Access Compliance Report Public Rights-of-Way (Curb Ramps)

Main Street: FILLMORE_DR Cross Street: ARTHUR_DR Location: SE

ADA ID: RPAT211124110158 Ramp Type: Type 4 - Parallel Initial Pass/Fail: Fail Overall Compliance: No Severity Score: 4

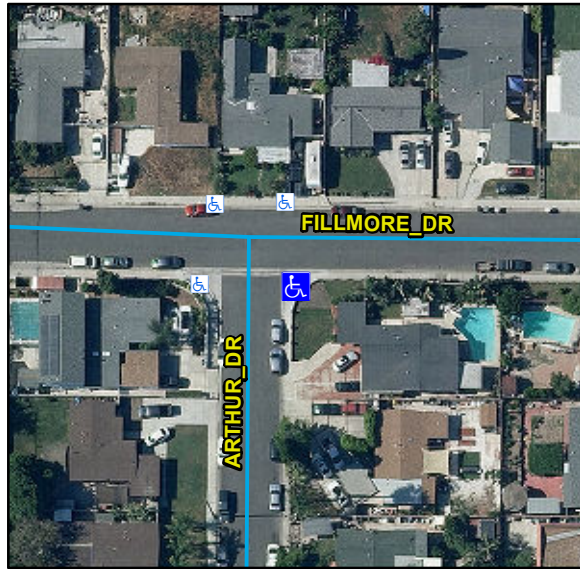
Compliance	Description	Data	Compliance	Description	Data
N/A	Ramp Length LT (in)	111	N/A	Ramp Length RT (in)	114
Yes	Ramp Width LT (in)	48	No	Ramp Width RT (in)	47
Yes	Ramp Run Slope LT (%)	4.3	Yes	Ramp Run Slope RT (%)	4.6
Yes	Ramp Cross Slope LT (%)	1.7	Yes	Ramp Cross Slope RT (%)	0.9
N/A	Landing Present	N/A	N/A	DWS Provided	N/A
N/A	Landing Length (in)	N/A	N/A	DWS Contrast	N/A
N/A	Landing Width (in)	N/A	N/A	DWS Length (in)	N/A
N/A	Landing Run Slope (%)	N/A	N/A	DWS Full Width	N/A
N/A	Landing Cross Slope (%)	N/A		DWS Offset Type	N/A
N/A	Landing Movement Obstructed?	N/A	N/A	DWS Offset Left (in)	N/A
	Landing Movement Type	N/A	N/A	DWS Offset Right (in)	N/A
N/A	Landing Shared	N/A			
N/A	Clear Space	Yes			
N/A	Clear Space To Crosswalk (in)	N/A			
N/A	Marked Crosswalk 1	No	N/A	Marked Crosswalk 2	No
	Crossing 1 Direction	N		Crossing 2 Direction	W
	Marked Crosswalk 1 Width (in)	N/A		Marked Crosswalk 2 Width (in)	N/A

Remove & Replace Curb Ramp With Two New Directional Ramps or Equivalent.

R304.5.1, STD 1115
